Case Number: BOA-23518

Action Requested: Special Exception to allow an Accessory Dwelling Unit in an RS-3 District (45.031-D); Variance to allow a Detached Accessory Building/ Dwelling Unit to exceed one story or 18-feet in height and to exceed 10-feet in height to the top of the top plate in the rear setback (Section 90.090-C2); Variance to reduce the required 50% open space for a non-conforming lot (Sec. 80.020-B); Variance to permit more than 30% coverage of the rear setback by a Detached Accessory Buildings/Dwelling Units (Sec. 90.090-C, Table 90-2):

Location: 1508 E. 20 St. S.

BOARD OF ADJUSTMENT CASE REPORT

SITE PLAN SHEET: 2

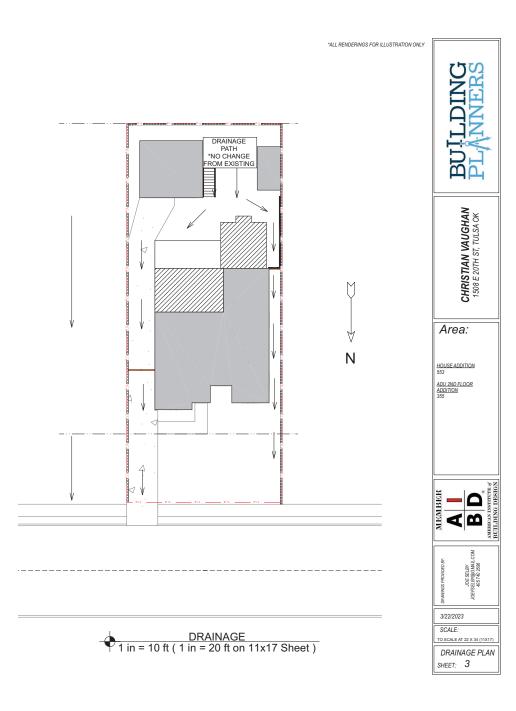
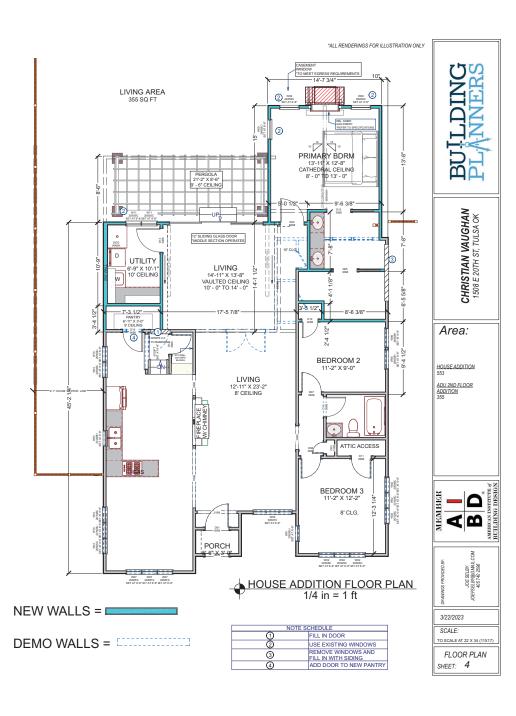
Review Comment: This property is located in the Swan Lake History Preservation district. Contact INCOG regarding an HP permit for the carport, since it is visible from the street. Provide that HP permit once obtained, along with the rest of the revisions required.

Review Comment: Several things need clarified or revised on the site plan.

- 1) The location of the retaining wall needs to be revised on the site plan to show that no part of the wall, including the footing, will cross the property line. Site plan should clearly show that the wall and footing will remain on the property.
- 2) Clarify the overall height of the fence. It's shown to be a 3' tall retaining wall with a 6' tall stockade fence. What is the height from the top of the fence to grade below on your side of the property?
- 3) Plan shows an addition to an AUD, do you mean an accessory dwelling unit (ADU)? Revise the plans to show the height to the peak of this building's roof as well as the height of the side wall, to the top of the top plate.

Please revise the site plan to clarify these issues. Additional deficiencies may be found which will need to be addressed prior to issuing a permit.

Review Comments: A 5' side setback is required, regardless of the location of any existing structures. The house addition is only shown to be 4' 2" from the side property line. You may increase the setback to 5 feet from the property line, or pursue an administrative adjustment from INCOG to reduce the side setback in an RS-3 zoning district by up to 20% (1 foot).

Review Comment: Table 90-1, Footnote [2], allows carports to be located as little as 3' away from side property lines. Please revise the carport so that it is set back at least 3' from the side property line.

Review Comments: This lot is considered an existing nonconforming lot. The lot area is 6,100 square feet; this means 3,050 square feet must remain as open space. Per Section 90.080-B, the driveway does not count as open space. You are proposing less than 50% of the lot to be open space since the areas of the driveway and all buildings and structures cover more than 3.050 square feet of area. Please revise plans to indicate that 3,050 square feet of this lot will remain as open space.

Review Comment: RS-3 lots have a 20' rear setback, and this lot is 50' wide, therefore the rear setback area is 1,000 square feet. In RS-3 districts, only 30% of the rear setback area may be covered per Table 90-2. This permit cannot be approved as applied for since it appears the existing accessory structures exceed 30% coverage already.
